The City of Newcastle

JRPP No.	2015HCC016
DA No.	DA 14/1152
Proposal	ERECTION OF ONE(1) X TWO-STOREY, THREE(3) X THREE-STOREY BUILDINGS TO BE USED FOR LIGHT INDUSTRIAL PURPOSES AND ASSOCIATED SITE WORKS AND PARKING AREA
Property	609 MAITLAND ROAD MAYFIELD WEST LOT 1 DP 369641
Recommendation	REFUSAL
Applicant	DUBBO HOLDINGS & KINGSTON COMMERCIAL PTY LTD
Report By	DEVELOPMENT AND BUILDING SERVICES

Assessment Report and Recommendation

Figure 2 - Site Zoning

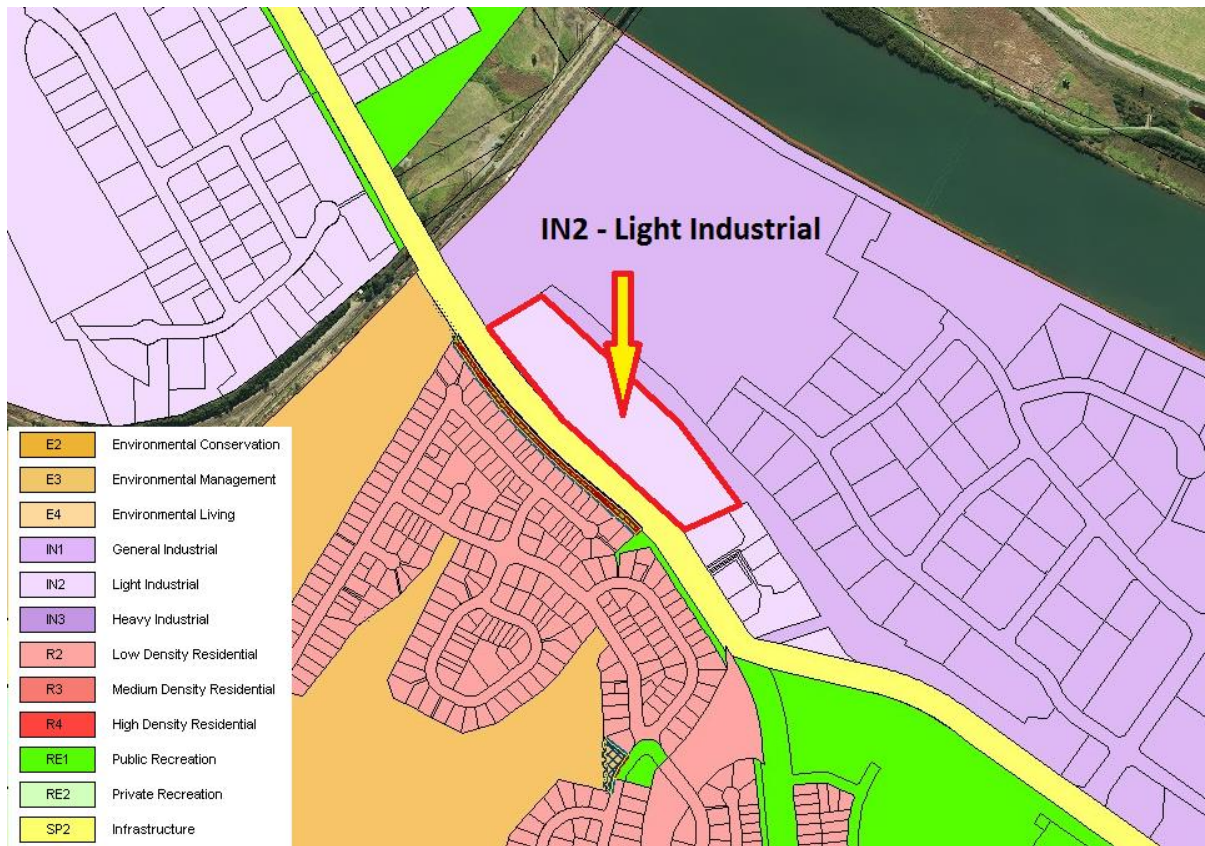
The subject site is zoned Zone IN2 Light Industrial (see zoning Figure 2 below).

This zone allows for several uses which the proposed buildings could possibly be used for such as *industrial training facilities*, *industrial retail outlets* and *light industries* (ie which is inclusive of *high technology industry*).

Concern was raised with the applicants that the design of the proposal was not conducive to light industrial uses and that insufficient detail was provided regarding the nature of likely uses proposed on a speculative basis. Further details in this respect have not been provided by applicants.
